# Sassamon Trace Golf Course

## Town of Natick ADA Transition Plan

August 2023

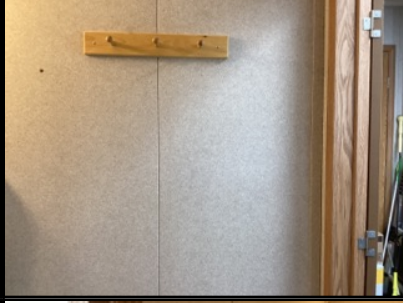
- Recommend providing a 48" wide stone dust route to the driving range.
